# UNITED STATES PATENT AND TRADEMARK OFFICE

APPLICATION NO.	FILING DATE	FIRST NAMED INVENTOR	ATTORNEY DOCKET NO.	CONFIRMATION NO.
10/720,083	11/25/2003	Etsuo Miyoshi	2003-1699A	4944

**Office Action Summary**

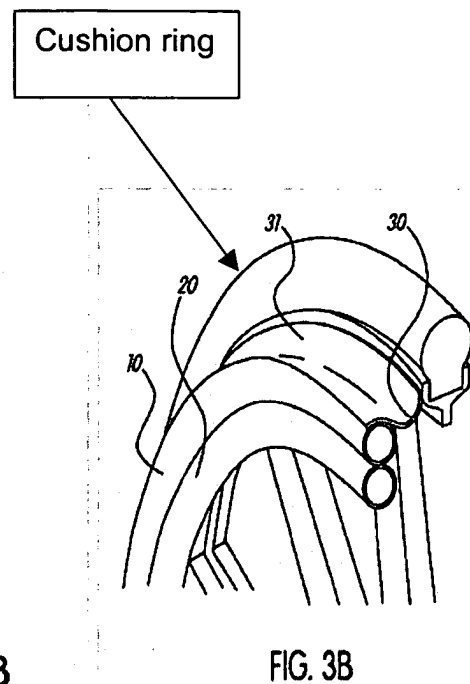
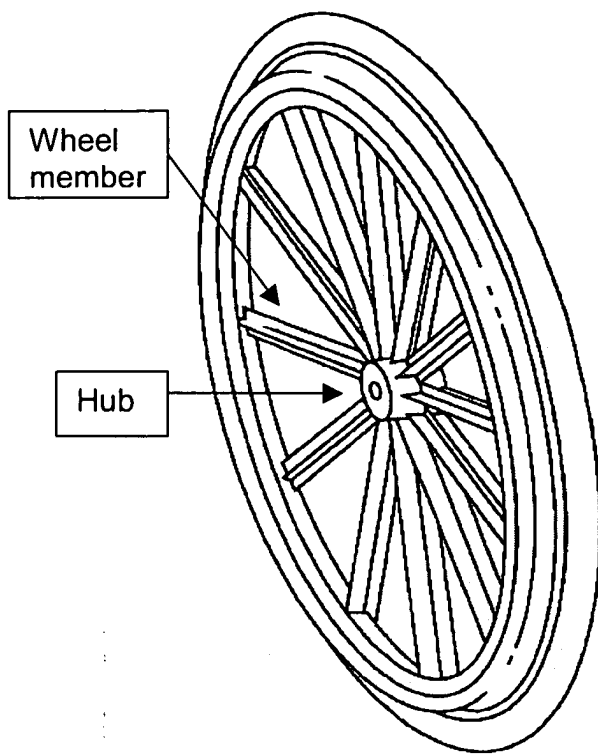
a hub member (Hub, see Examiner's annotated Figure 2B) rotatably connectable to a wheel chair part at the center of the rim member via a wheel member (wheel member, see Examiner's annotated Figure 2B);

a rubber cushion ring (cushion ring, see Examiner's annotated Figure 3B) fixed on the outer periphery of the rim member (40);
